RE: Village Hall and Site Construction, EN2104 & EN2105– Request for information

Thank you for your interest in the Village's project. Highlighted responses to requests for information are listed below. Please note the list is a compilation of questions submitted from multiple Contractors and Suppliers.

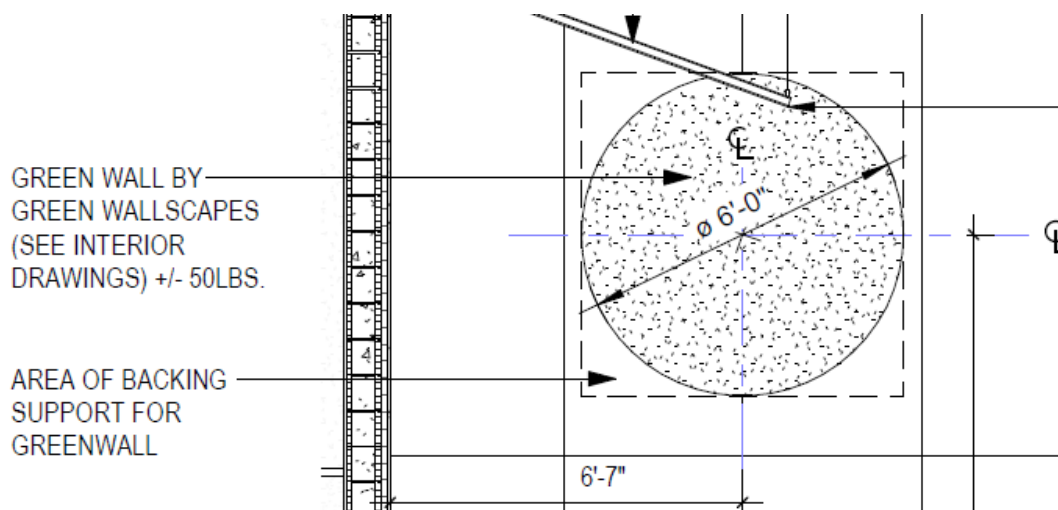
Q. Can you tell me where to find additional/detailed info on the Green Wall, details of the circled area in drawing A-4.50? it is the one with the section: 4 Main Lobby (127) Elevation 3

*As stated in the drawings, the green wall feature is provided by Green Wallscapes. These items are all custom made by the company for the customer as an "art" piece. Our Interior Designer contacted the company and obtained the **below quote** for informational purposes. It is a 6'-0" diameter preserved moss and fern, circled-shape installation. The attached document does not constitute the final price for the item, it was obtained for informational purposes. The final piece may vary slightly in appearance from that shown in the attached picture. Bidders must contact Green Wallscapes (contact information attached in quote) for additional information regarding delivery and installation of item. Drawings call for backing behind wall in this location as we were informed that the piece can weigh up to 50 lbs. **no addendum***
